MECKLENBURG COUNTY
DEPARTMENT OF ENVIRONMENTAL HEALTH

APPLICATION FOR SOIL INVESTIGATION

APPENDIX H
SITE EVALUATION

SITE INVESTIGATION REPORT
INDIVIDUAL SEPTIC TANK SYSTEM
WITH SUBSURFACE,
SOIL ABSORPTION,
EFFLUENT DISCHARGE

* See Diagram on Back (Include: Soil areas, property lines, roads, streams, gullies, wet areas, fill areas, wells, water bodies, slope patterns)

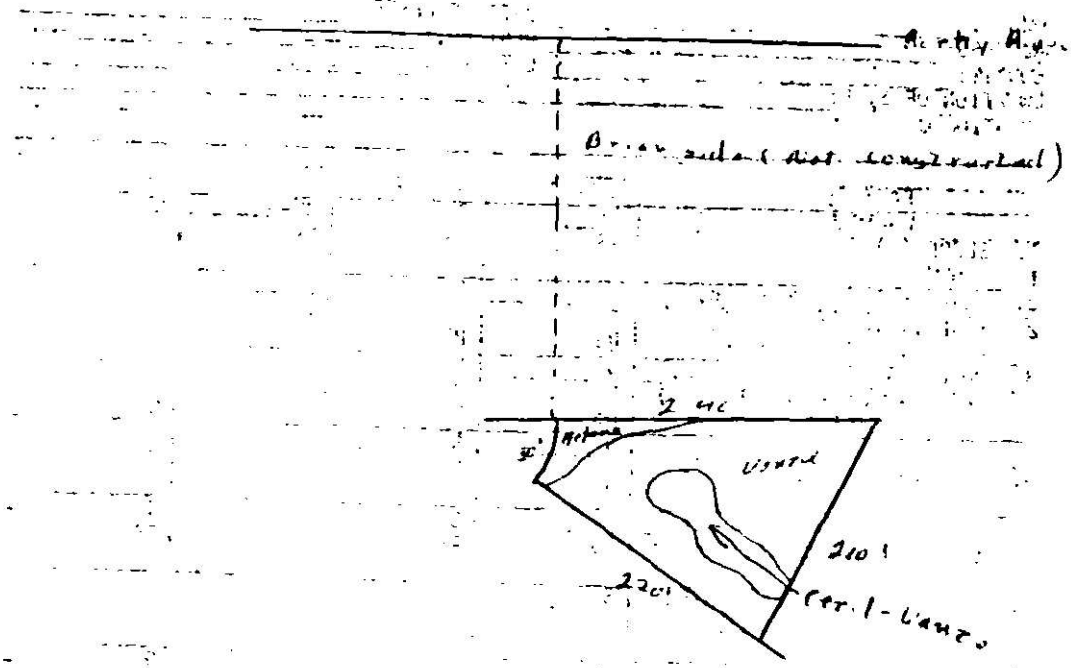
FACTORS	AREA 1	AREA 2	AREA 3	AREA 4
1. SLOPE (%)	(S) 2-8 % PS U	(S) 2 to 8 PS U	S PS U	(S) 2-8 % PS U
2. SOIL TEXTURE (12-36 in.) (Sandy, loamy, clayey, Note 2:1, Clay)	S Sandy (PS) 2-1 U Clay	S PS 2-1 clay (U)	S PS U	S PS 2-1 Clay (U)

3. SOIL STRUCTURE (12-36 in.) (Clayey Soils)	S (PS) Blocky U	S PS Massive (U)	S PS U	S PS Massive (U)
4. SOIL DEPTH (In.)	(S) 48" PS U	(S) 48" PS U	S PS U	(S) 48" PS U

5. RESTRICTIVE HORIZONS (In.) (Impervious Strata, Rock)	(S) None PS U	(S) None PS U	S PS U	(S) None PS U
6. SOIL DRAINAGE/GROUNDWATER (External & Internal)	(S) 72" To ground water PS U	(S) 72" To ground water PS U	S PS U	S Seasonal Perched Water Table PS (U)

7. SOIL PERMEABILITY (Percolation Rate)	S Moderate (PS) To slow U	S Slow PS (U)	S PS U	S PS 1" slow (U)
8. OTHER (Specify)	S Inadequate PS Area (U)	S PS U	S PS U	S PS U

9. SITE CLASSIFICATION	Unsuitable	Unsuitable		Unsuitable
SOIL SERIES	Enon-Wehadkee	Vance		Helena

Soil Structure Massive
Soil Permeability Unsuitable
Site Classification Unsuitable

Sites classified as Unsuitable are not acceptable for soil absorption of sewage effluent. However, if engineering, geologic, soil, and environmental studies indicate that a suitable septic tank system or a suitable alternate system can be expected to function satisfactorily, such sites may be re-classified as Provisionally Suitable. (Section 10 of the North Carolina Administrative Code 10 A,.1910)
